Job No: P29679

Name: BAXTER

TOTAL REMEDIAL WORKS
LISTED ON PAGE 30F3

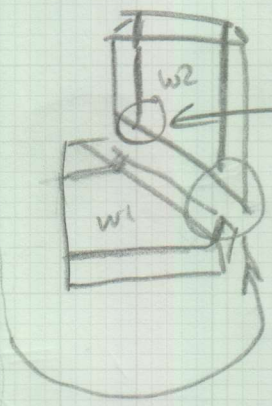
← Fit
From Piece
ON SITE

← NEEDS NEW PIECE - CUT PLAN

2 Tiles

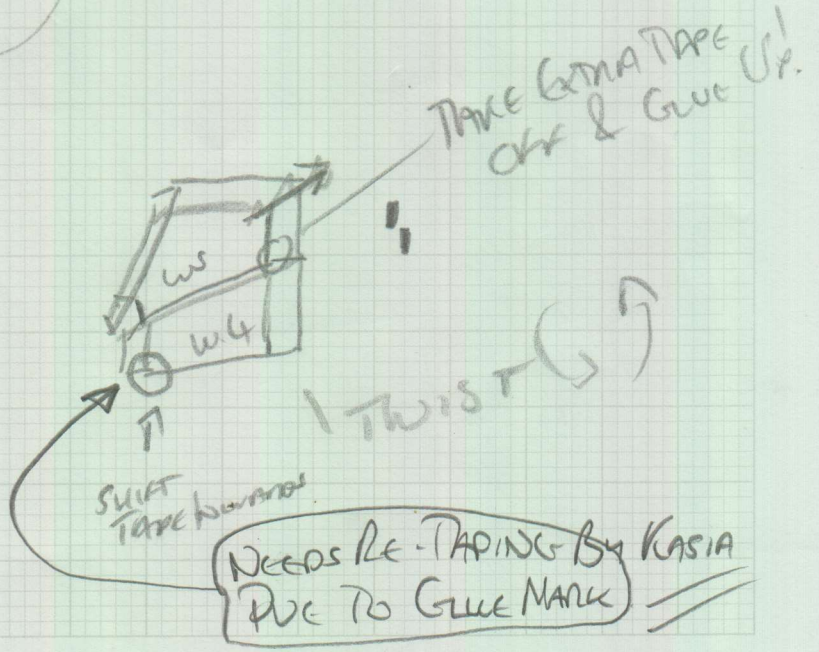
W1 = 74 x 106
RE-CUT Slightly
Smaller To Fit?
SPRAY GOGGLE TO
LINE UP.

REMOVE
W2,
NEEDS
TAPE
STRAIGHTENED
BY KASIA

WS = 65 x 90
SAFETY

NEEDS RE-TAPING BY KASIA
DUE TO GLUE MARK

- FIT T/L FROM SPARE CARPET ON SITE
- REPLACE 1/4 (1) + BOTTOM 1/4 (115 x 400)
- REMOVE W2 SO TAPE ON INSIDE EDGE CAN BE SEWN STRAIGHT!
- CUT BACK EXCESS TAPE & SHORTEN S/E ON OUTER EDGE OF W1 RISEN, USE SPRAY TO HOLD TIGHTER TO STEP
- REMOVE W4 TO BE RE-TAPED! use UP PROPERLY
- CUT BACK EXCESS TAPE ON W5 & SPRAY IN AS NECESSARY
- STRETCH & FINISH 1st FLOOR LANDING DOWN RISEN (CHECK BUMPS BENEATH!)
- REMOVE DOUBLE STACK OF S/E

1st LANDING

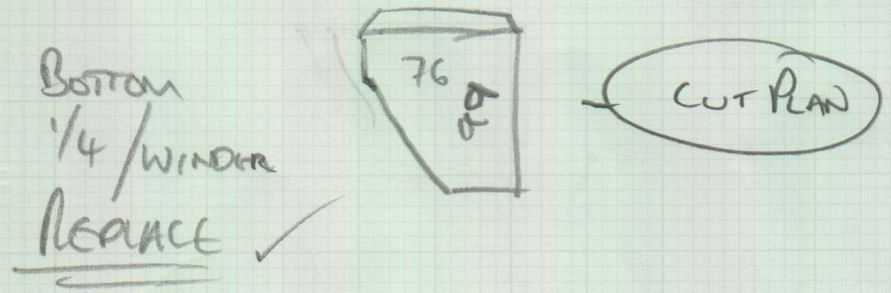
STRETCH DOWN RISEN!! - OR REPLACE IF NOT POSSIBLE
PULL BACK TO INSPECT LUMPY FLOOR BENEATH

BOTTOM STEP - STACKED S/E?!
ON RISEN!!
